# ADDENDUM No. 1

## RFP No. 23-59

### East Medical Center Drive Bridge Rehabilitation and Widening Project

SHEET NO. 69 OF 155

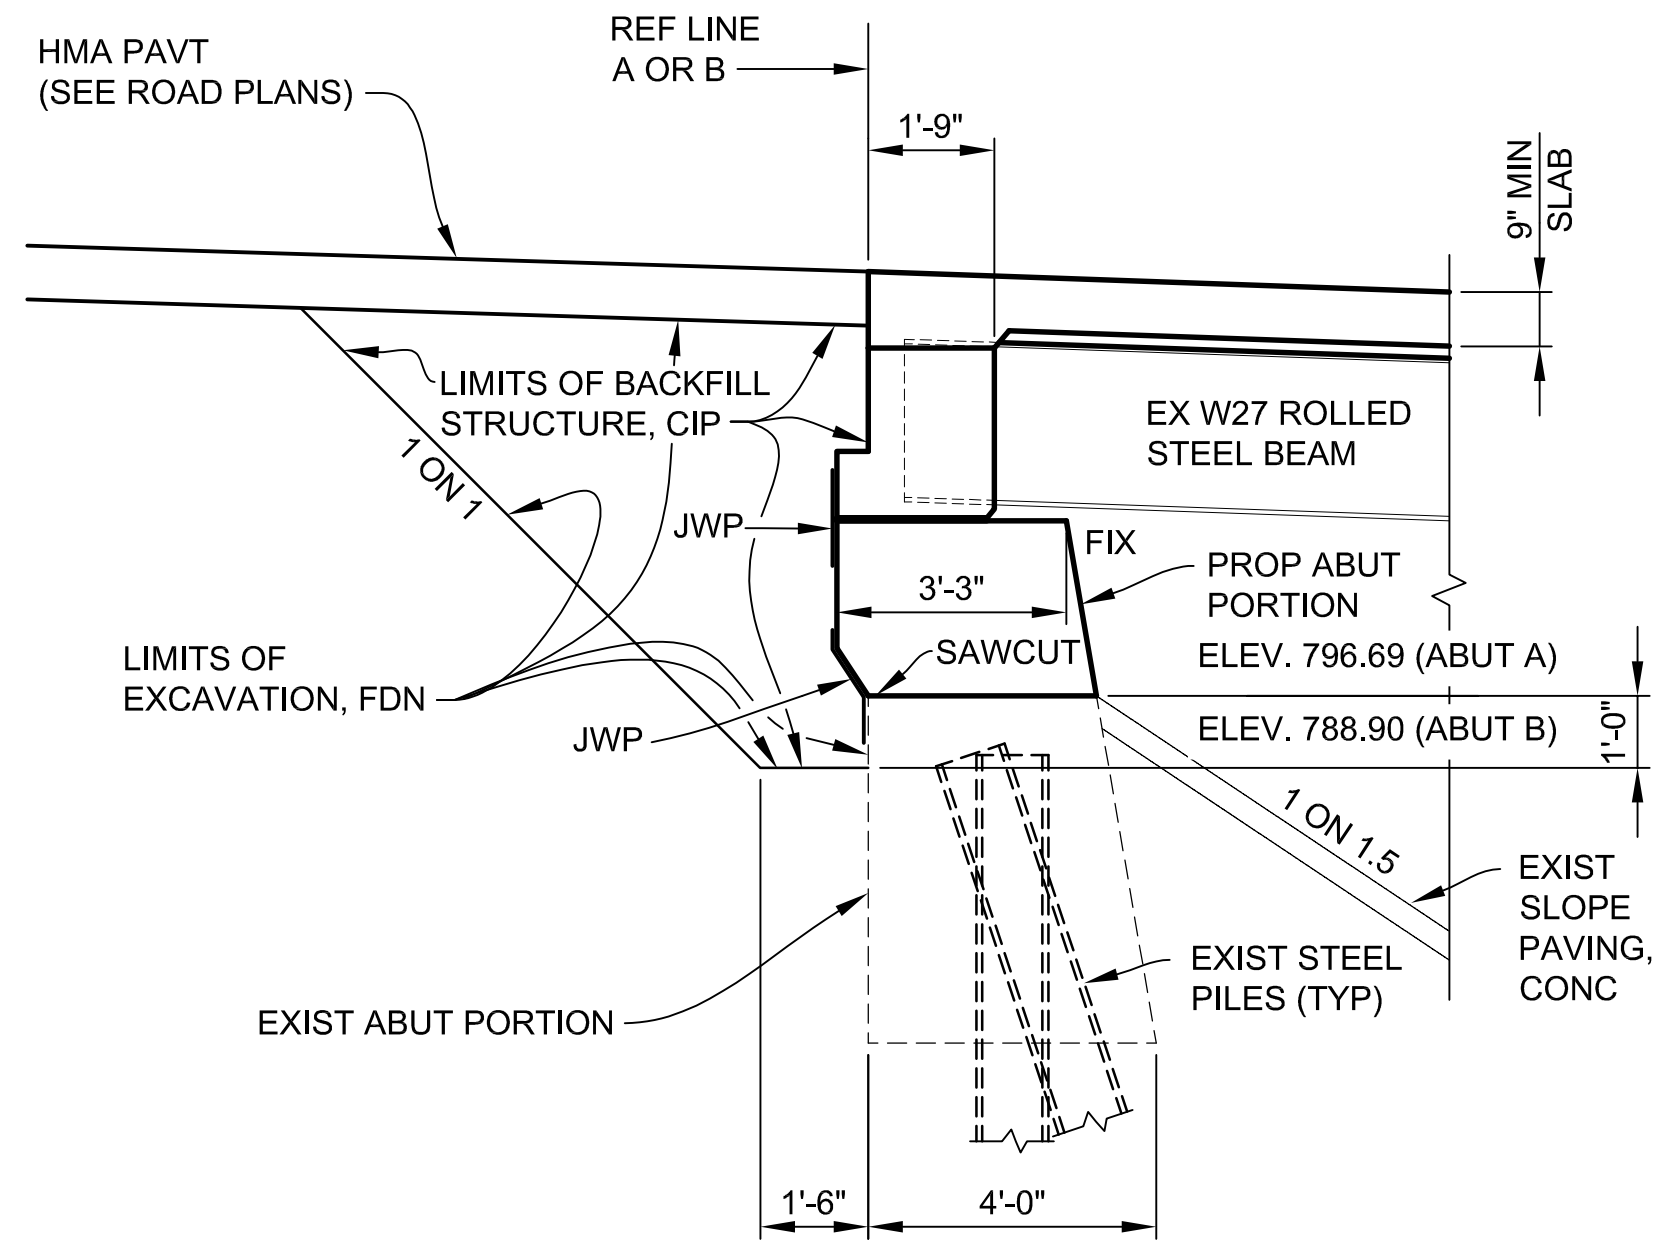
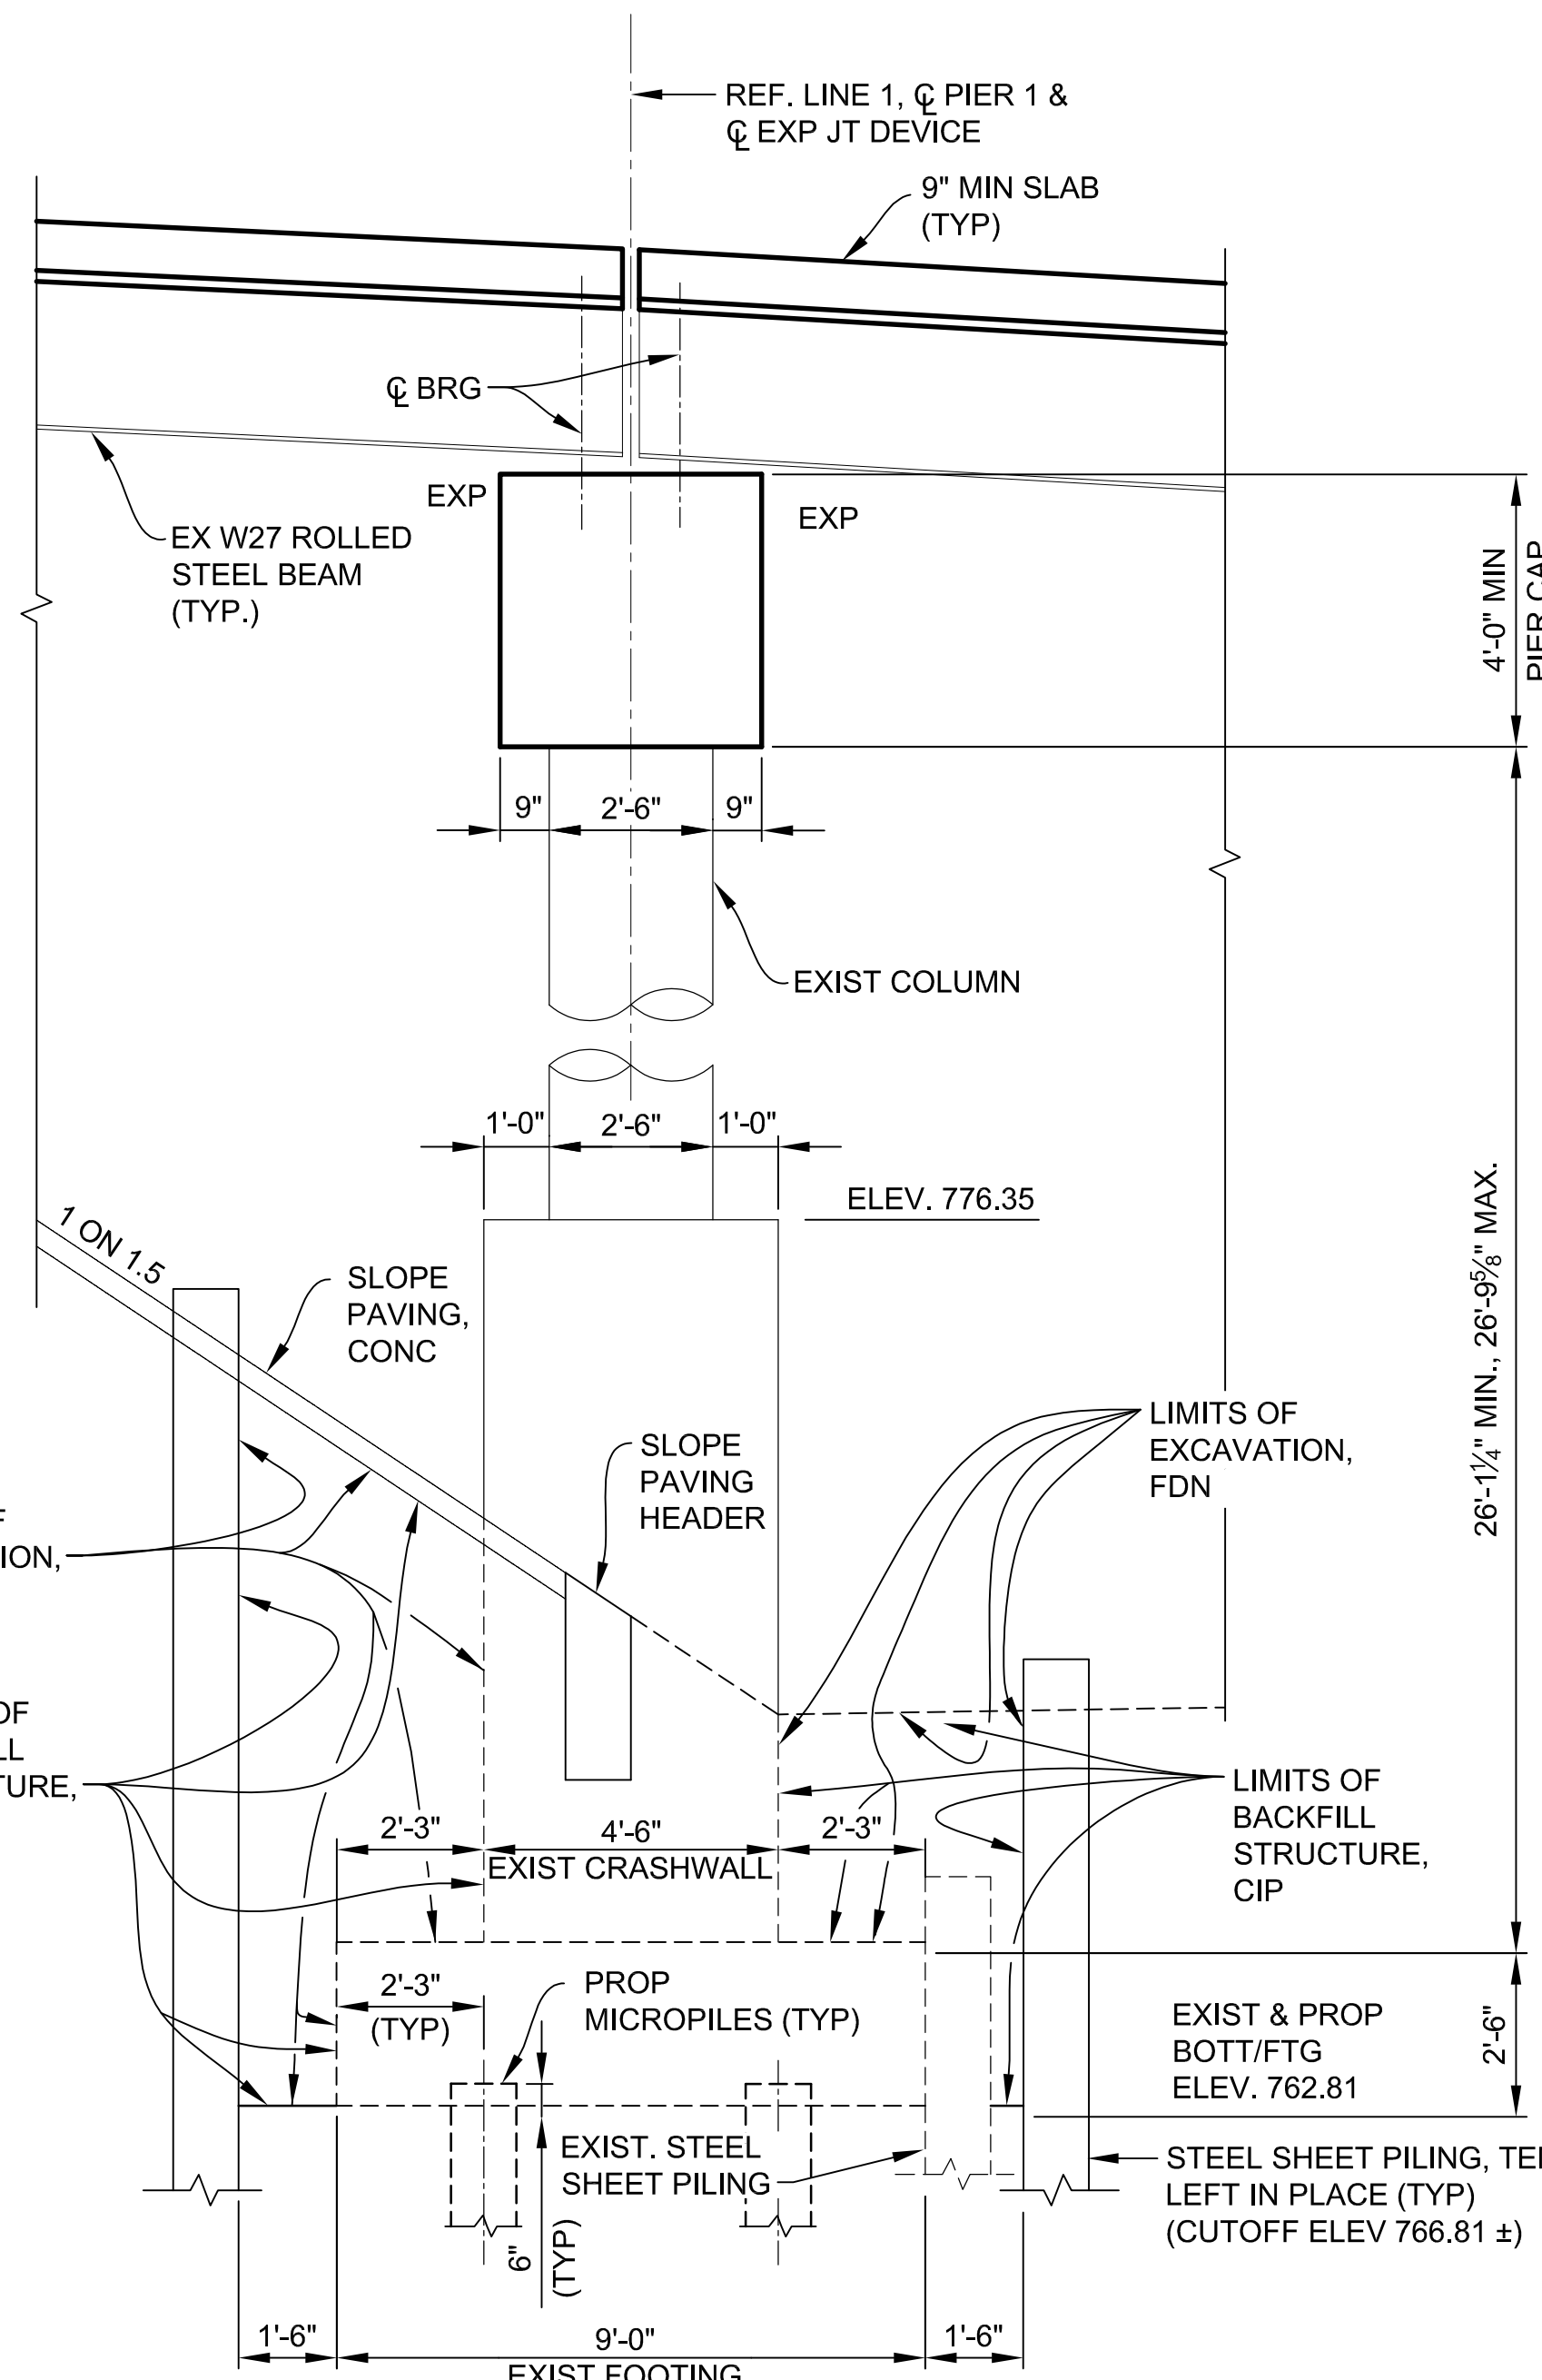
- Answer 7: The cost of the Track Inspector will be paid for by the City.
- Question 8: Drawing sheet 69 of 155 notes "Exist Permanent Steel Sheeting" at piers 1 and 2. The drawing infers that there is existing sheeting around the pier extension. The drawing shows "Steel Sheet Piling, Temp Left In Place" at the same location. Drawing 80 of 155 also details the 2 rows of sheeting. Please clarify.

- Answer 8: The drawing has been revised to show the existing sheeting only around the existing footing.
- Question 9: The drawing on sheet 69 shows 360 Sft of "Steel Sheet Piling, Temp" in the quantity table. Where is this item utilized in the plans?

Question 24: There exists several areas of concrete removal required for the construction of permanent works that are not specifically called out on the plans. These include the concrete slope paving in the area of the soil nails, permanent sheet pile walls and the pier wall extensions. There is also a concrete slab /walkway next to Pier 2 that will require partial removal in order to construct the footing extension. Will this removal be paid for under Bid Item 2047011 Sidewalk and Drive, Any Type or Thickness, REM? Please clarify how this work will be paid for.

- Answer 9: The "Steel Sheet Piling, Temp" pay item is meant to be used at the staging line at each abutment. A call out has been added to the plan view on the General Plan of Structure sheet.

Answer 24: The concrete slope paving for the soil nail walls, and the existing concrete slab behind pier 2 are already called out in the note for the removal pay item on sheet 69. The conc slope paving behind pier 1 for the soil nail walls should be paid for under the "Structure Rem, Portions" pay item as well. The note has been updated to include that.
